## **Results of Circulation**

### Consolidated Comment Report

**File:** OZS-2022-0011

**Proposal:** Two mixed-use, 48-storey towers with 4 and 6 storey podiums 1,149 residential units, at grade retail space including a daycare, and 466 parking spaces.

URBAN DESIGN COMMENTS\_SITE PLANNING

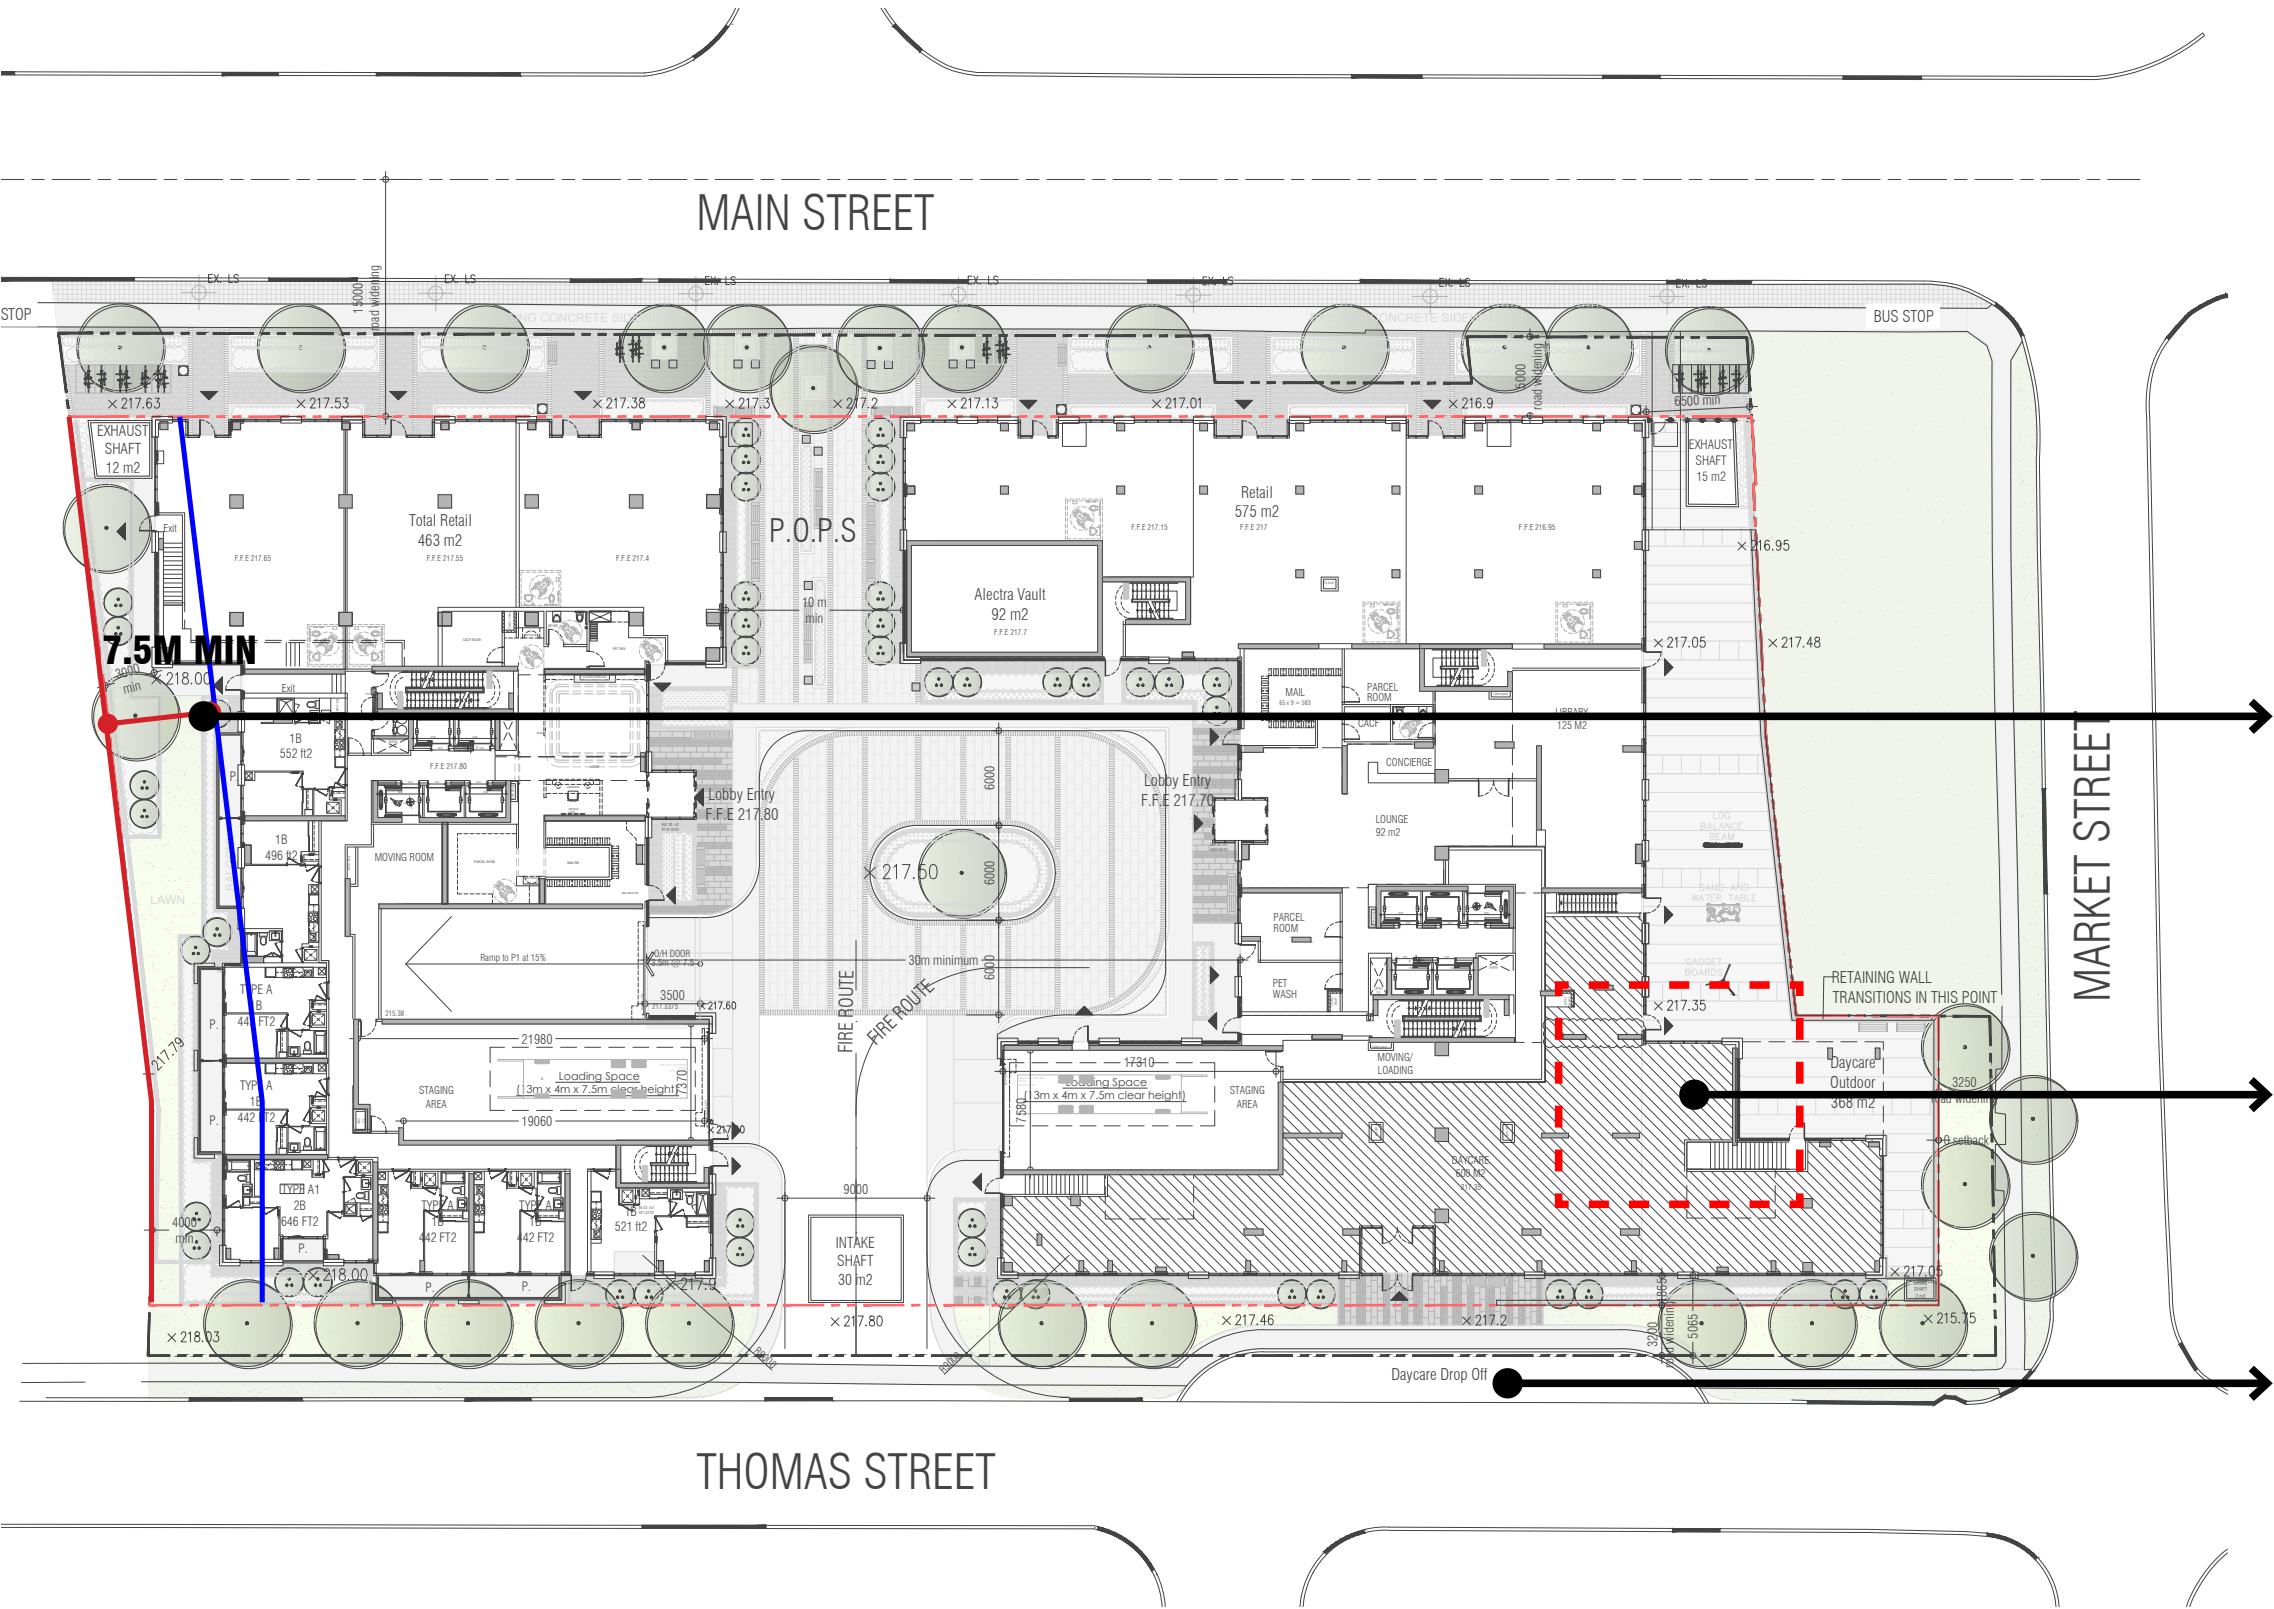
Minimum internal yard setbacks of the podium from the property line must be 7.5 meters in order to ensure for 15 m separation distances for any future developments the adjacent lots may see.

The daycare outdoor is very restricted, please consider flushing this niche with the podium wall to provide for a more open outdoor space.

The drop of lay by proposed for the Day care centre falls within the public right of way. Please see traffic comments and coordinate with them to address the same.

# URBAN DESIGN COMMENTS\_**BUILT FORM AND MASSING**

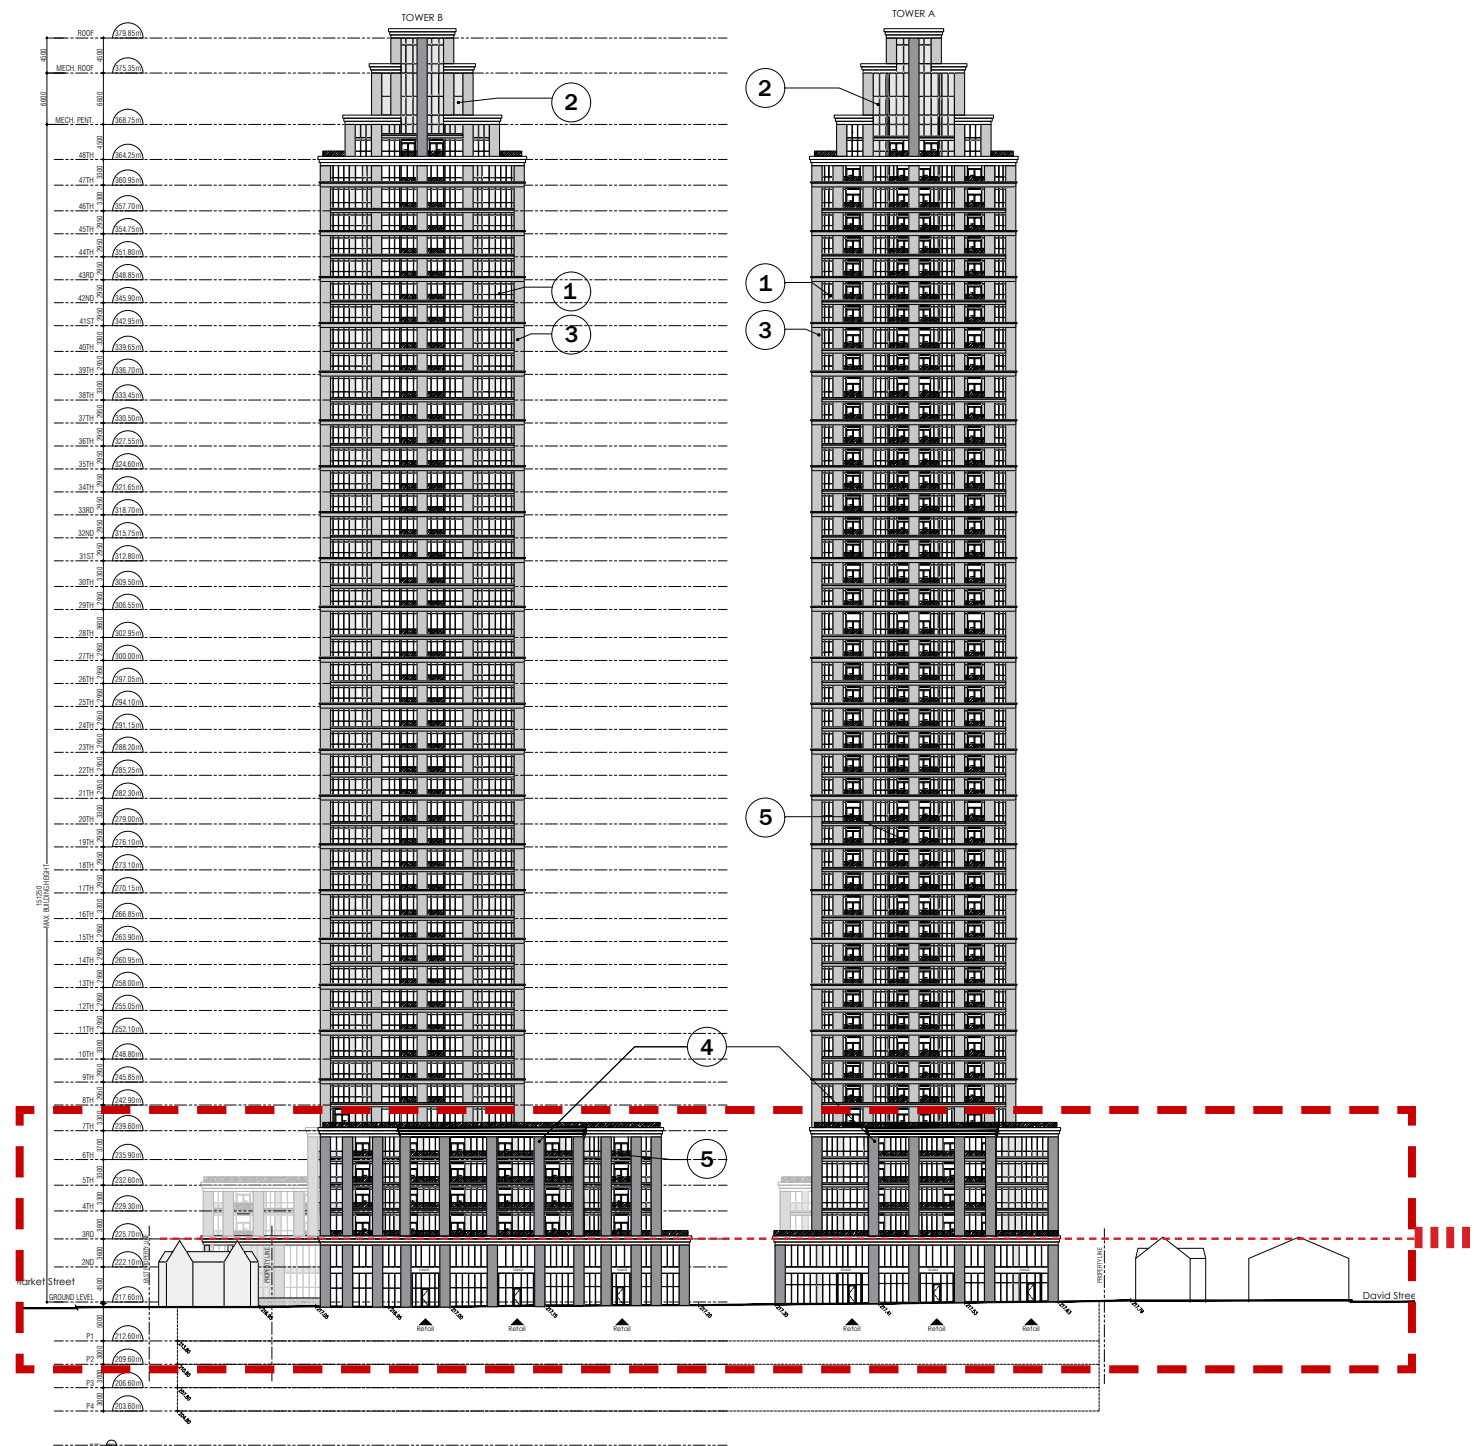
1. The base, middle and top of the building must be clearly defined and articulated well to create a pedestrian scale and diminish the scale of the towers.

2. Please be mindful that the proposed development is a part of the Main street heritage corridor and the proposal must aim to conserve and integrate adjacent and on-site heritage properties.

3. The podium articulation must be considerate of the existing scale and materials of the heritage context. Please provide for a 2 m stepback at the third floor to ensure continuity of the heritage scale at grade. See precedents.

4. The base must be articulated to elevate the heritage characteristic of the neighborhood. The use of high quality red bricks is strongly recommended for the podium.

5. Please consider providing for break floors/ stepbacks every 15 floors to break the verticality of the point towers. This can serve as an excellent opportunity to provide for outdoor amenities on these terraces for all age groups as well as help provide architectural relief. See precedents below
